<b>Subject:</b>  REAR CONSOLE LID IS LOOSE	<b>Bulletin No:</b> 09-045/14
	<b>Last Issued:</b> 10/23/2014

2014 Mazda6 vehicles with VINs lower than JM1 GJ \*\*\*\*\* 186473 (produced before May 14, 2014)

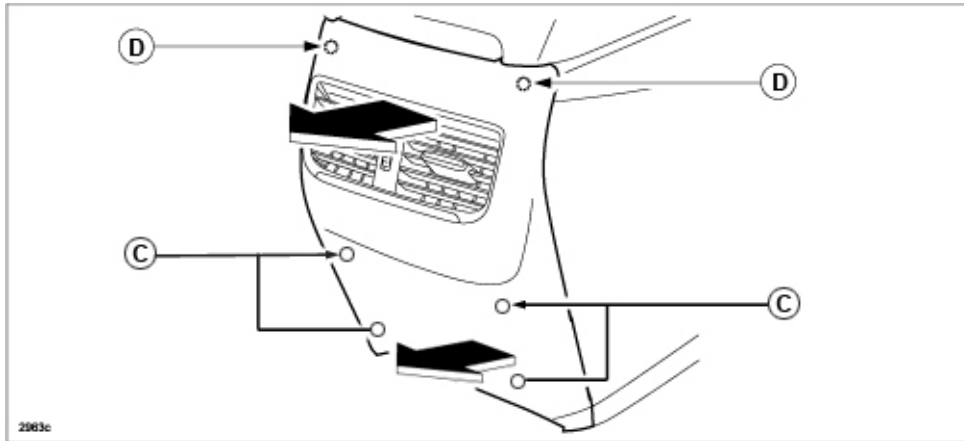
Some customers may complain about a loose rear console lid (A).

This may be caused by hinge pins coming partially off (B) or completely off.

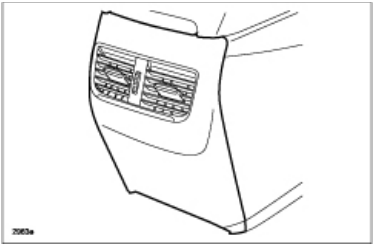
1. Verify customer concern.
2. Remove the rear console panel by pulling in the direction of the arrows shown below.

**NOTE:** Begin by pulling from the bottom to detach inner attachment clips (C), then continue pulling from the top to detach inner attachment clips (D).

3. Re-install the rear console lid pin(s) back to the original position.

4. Install a new rear console panel. (See PART(S) INFORMATION)

**NOTE:** The shape of the rear console panel has been changed, by adding a stopper rib to prevent the pin from coming off.
